25065 - THE LODGE 10 HIGHFIELDS BRIGHTON ROAD WARNINGLID RH17 5SY

In response to the recent comment issued by your drainage engineer we have altered the porosity design rate as the lowest recorded.

BRE 365 INFILTRATION AND BS 6297 DRAINAGE FIELD TESTING SUMMARY

Client	Mr & Mrs Vic and Lisa Mears
Project	The Lodge 10 Highfields Brighton Road Warringlid RH17 5SY
Drawing title	Proposed Site Drainage
Drawing status	PLANNING ISSUE

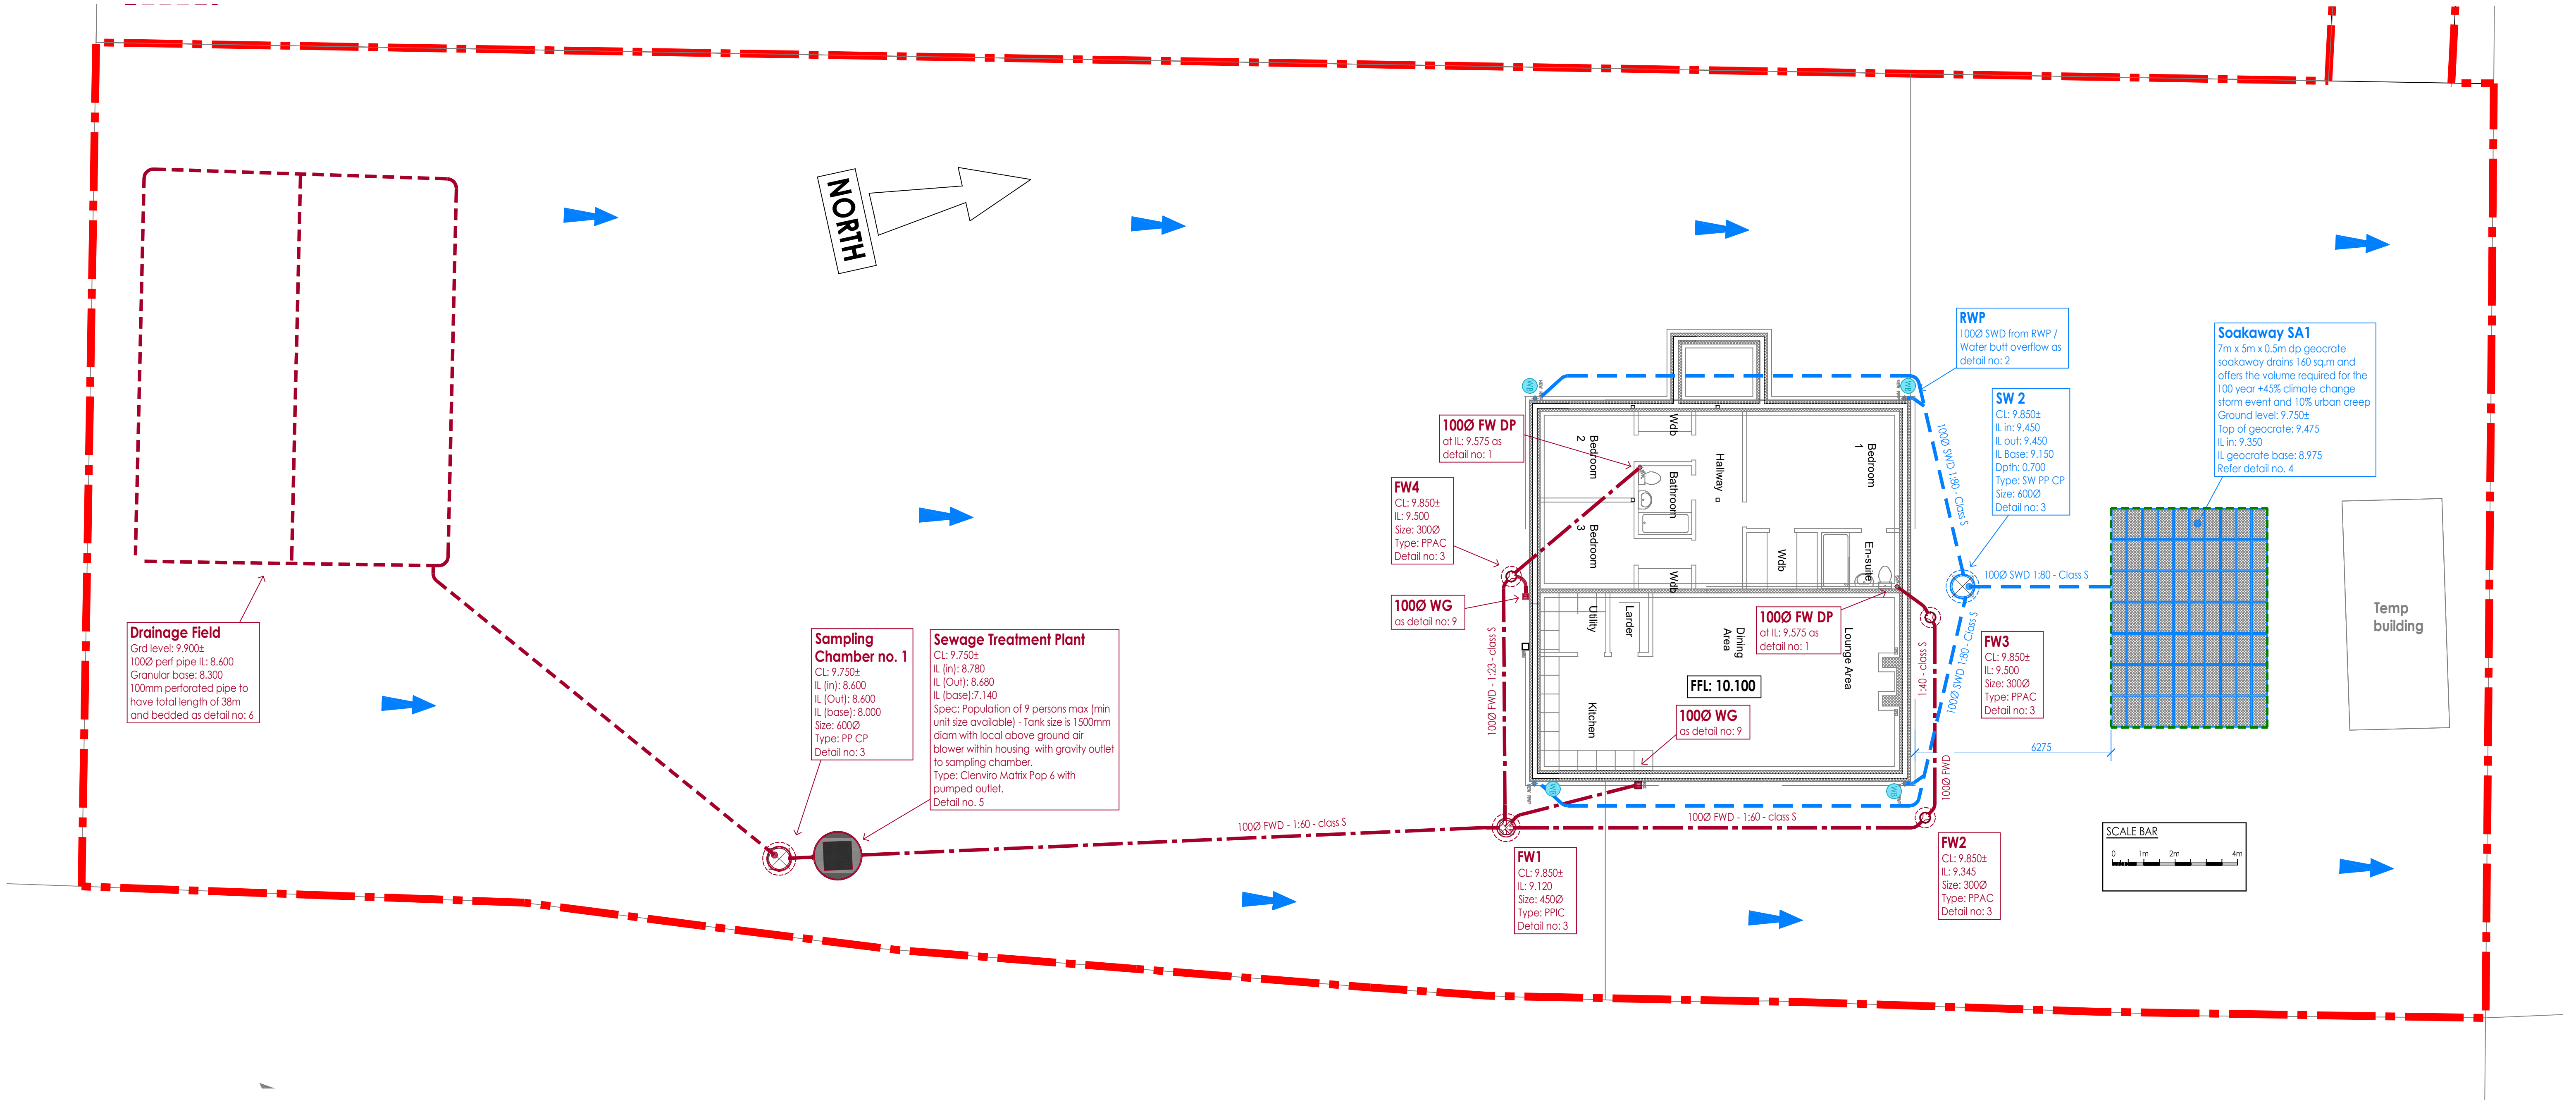
P3	Soakaway size altered to suit lowest infiltration rate figure.	27.03.2026	SAD
P2	Soakaway note clarified and distance indicated.	09.03.2026	SAD
P1	PRELIMINARY ISSUE	14.01.2026	SAD

The drainage hierarchy for SuDS design has been considered and reuse of rainwater has been provided where practicable for the client. The site has proven to infiltrate to ground as supported by in situ test results received from the clients builder and the lowest infiltration design rate of 1.028 x 10⁻² m/s has been established.

All rainwater infiltrates to the ground via geocrate soakaways which have been sized to provide sufficient storage for the 100 year + 45% climate change storm event. An appropriate factor safety of 1.5 has been used for the infiltration rate complying with Table S3.1 of the National SuDS Standard of July 2025.
